RFI# 40
Median Barrier Mounted Sign Support at Sta. 102+70

PARAPET & MEDIAN BARRIER MOUNTED SIGN SUPPORT

INTERSTATE ROUTE H-1 ZIPPER LANE EXTENSION
RADFORD DRIVE OVERPASS TO KEEHI INTERCHANGE
FEDERAL AID PROJECT NO. NH-H1-1(246)

"AS-BUILT"

MEDIAN BARRIER MOUNTED SIGN SUPPORT

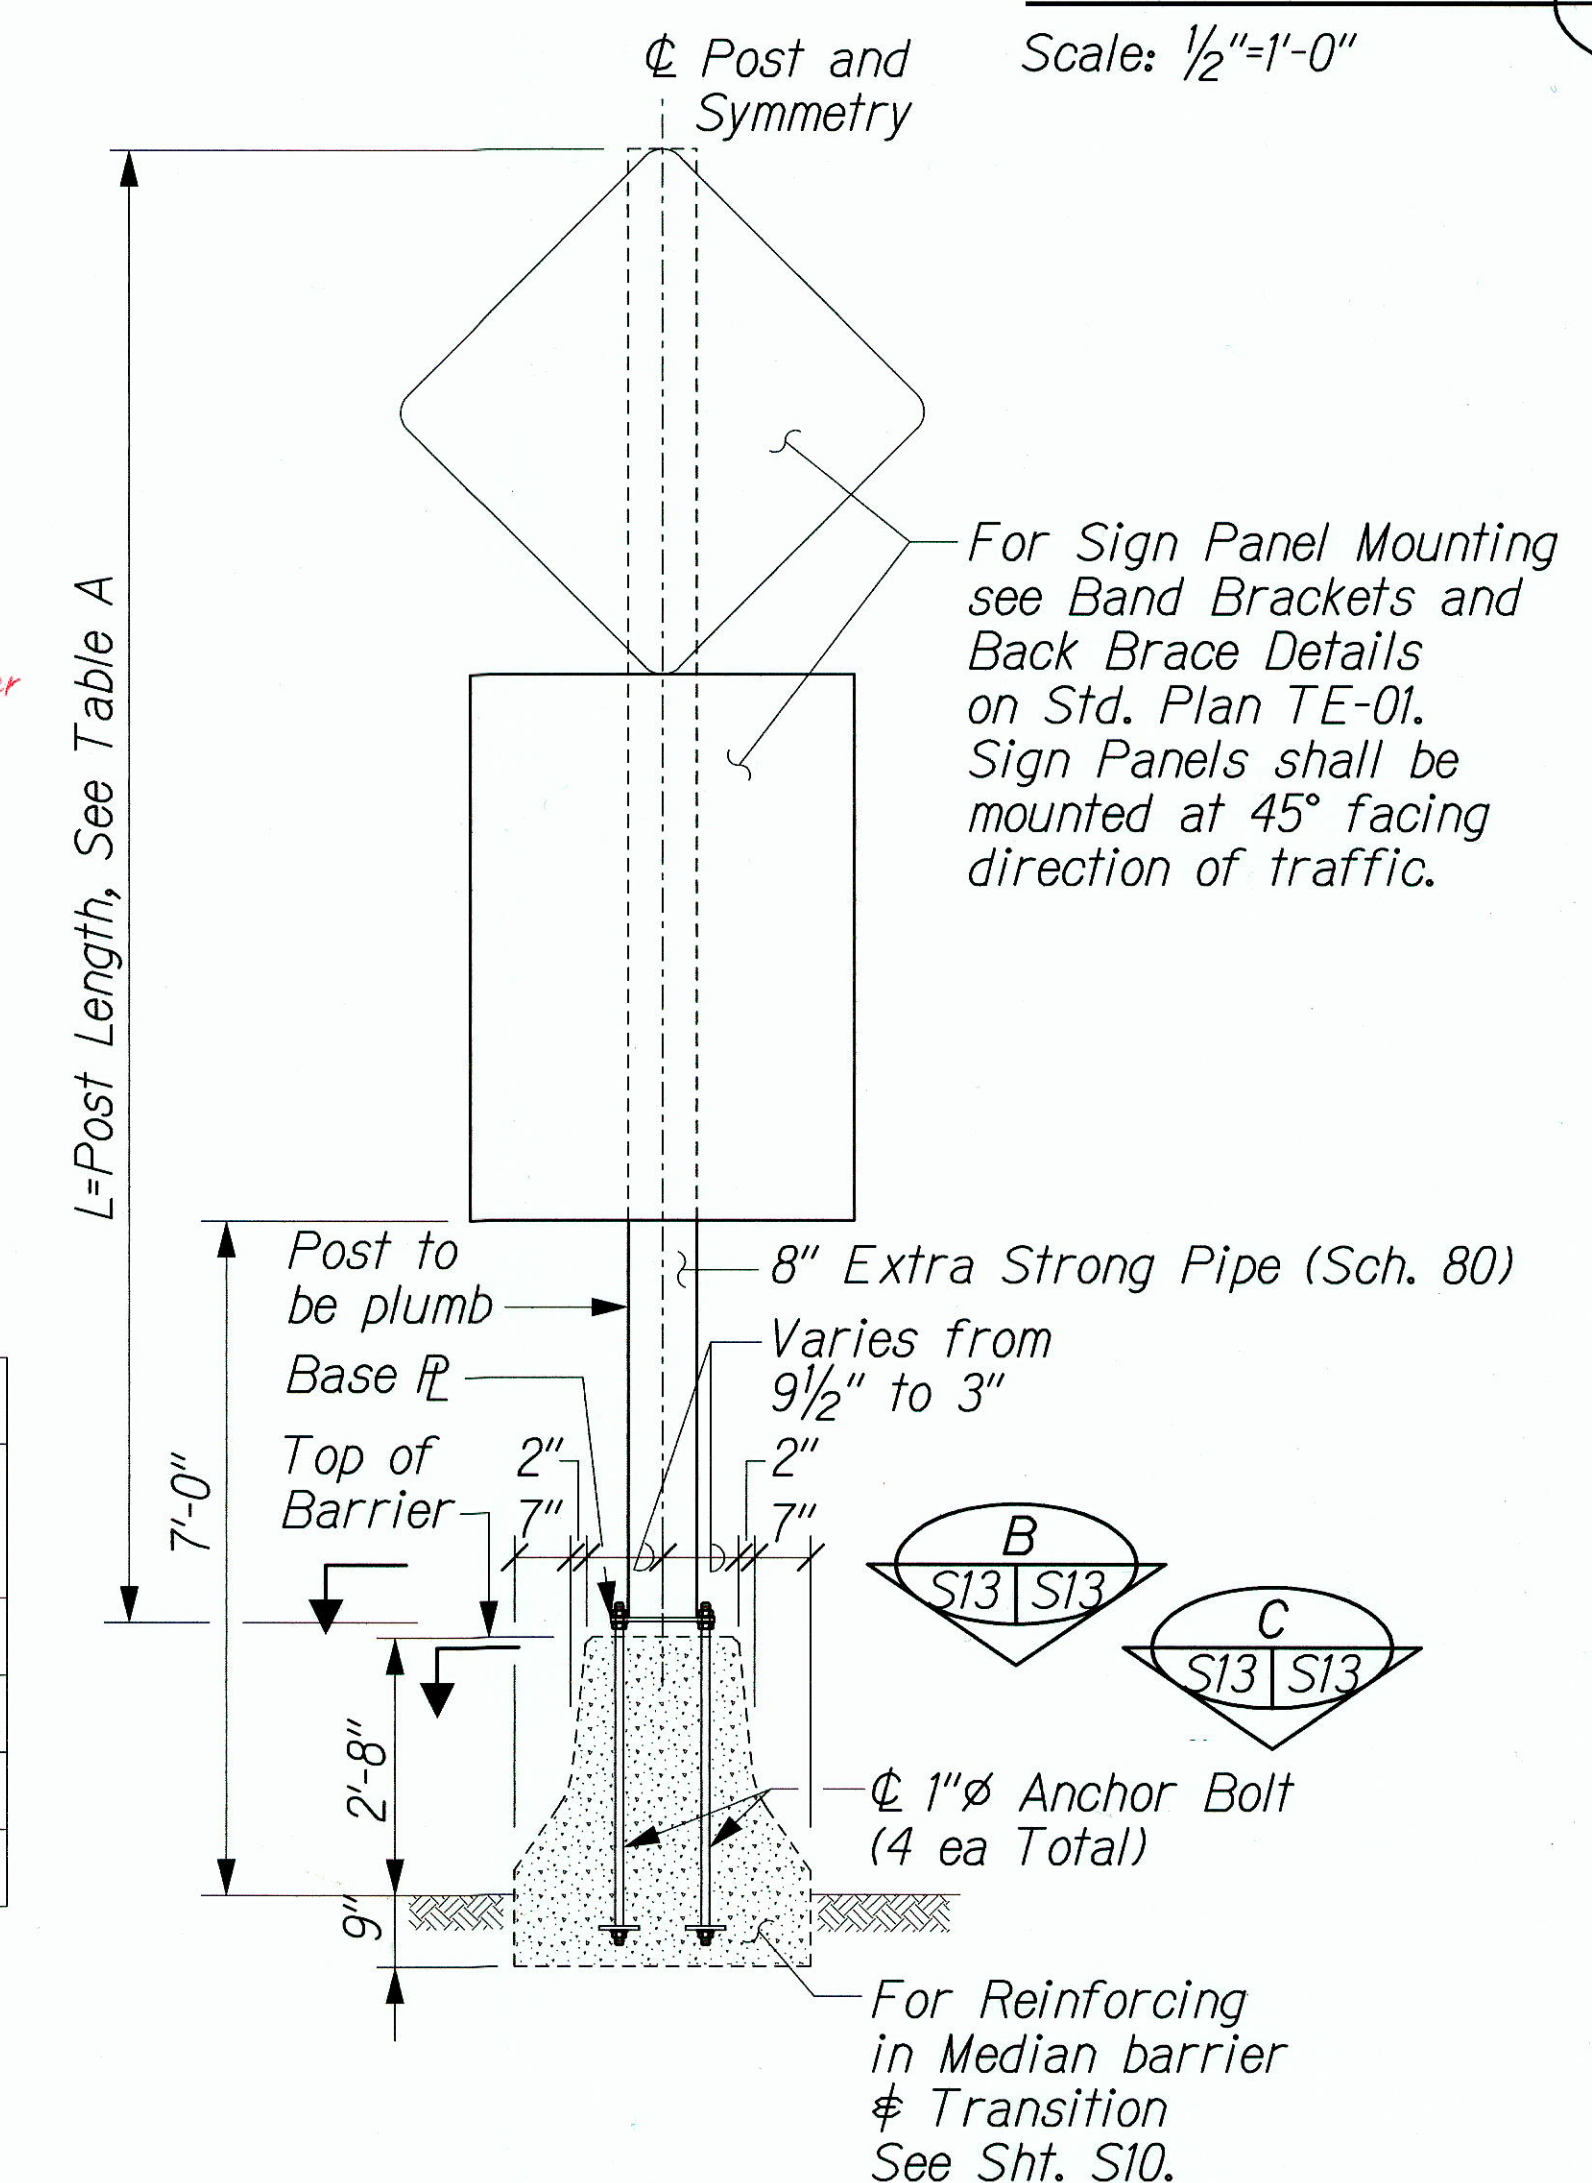
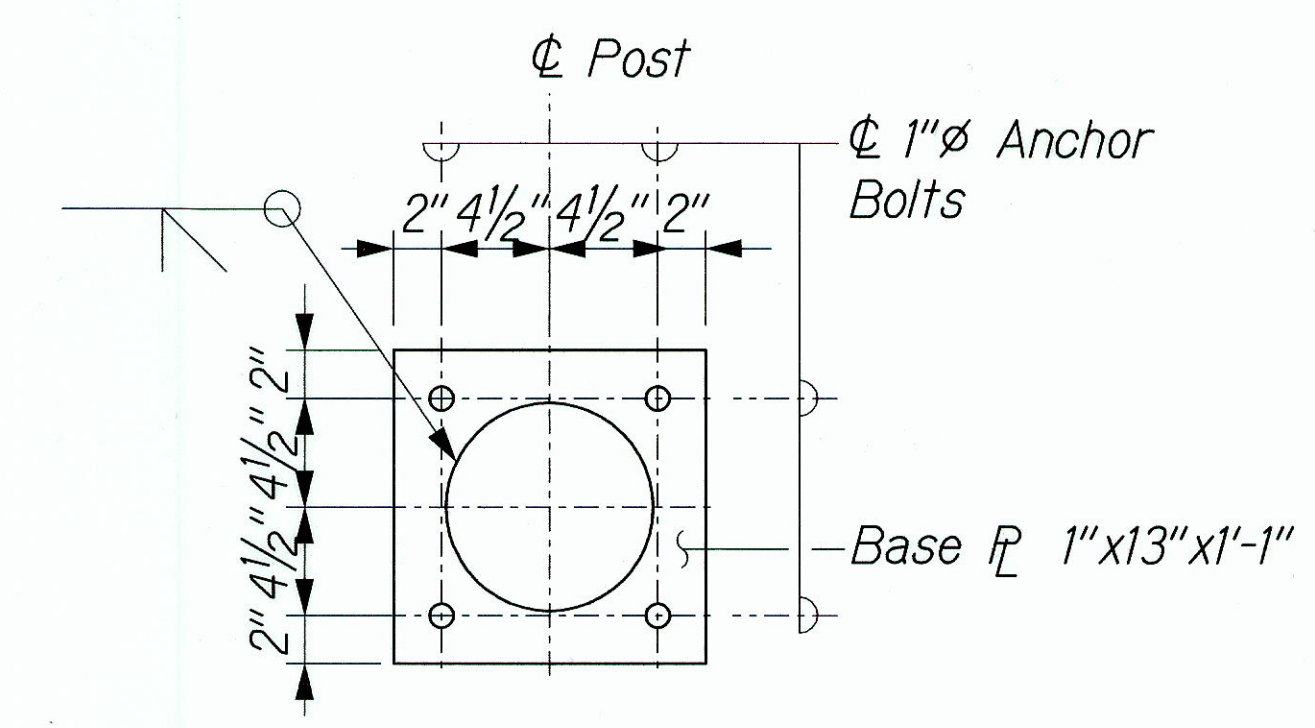
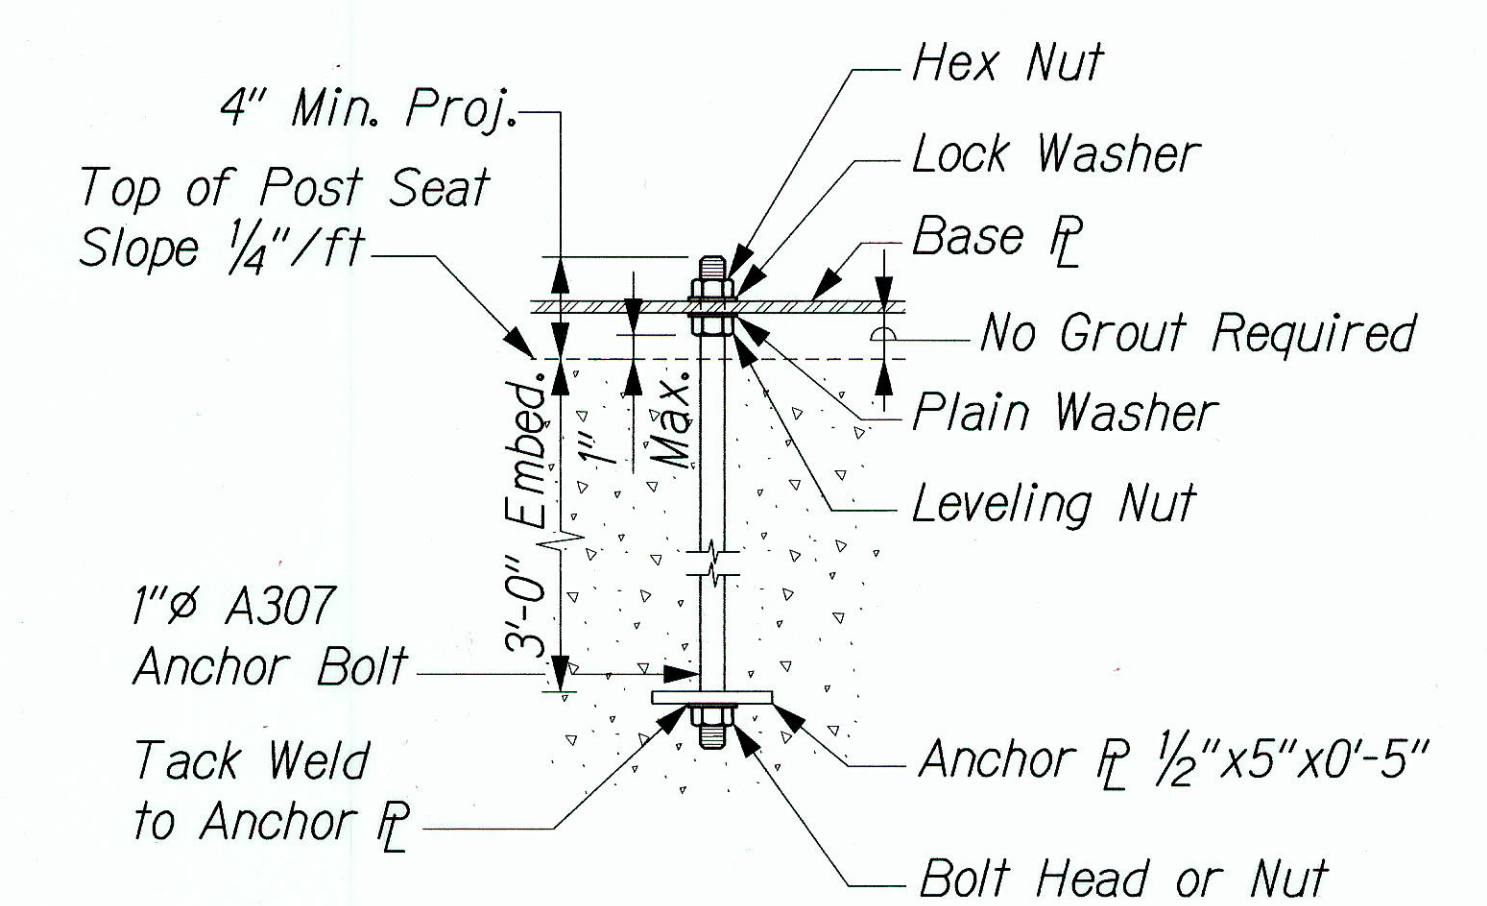
- Scale: 1/2" = 1'-0"
- @ H-1 @ STA. 67+30 **67+30.5**
 - @ H-1 @ STA. 76+90 **76+74.2**
 - @ H-1 @ STA. 83+40 **83+40.1**
 - @ H-1 @ STA. 102+70 **102+70**

TABLE A	
LOCATION H-1 @ STA.	POST LENGTH L
67+30	17'-0"
76+90	10'-4"
83+40	17'-0"
102+70	10'-4"
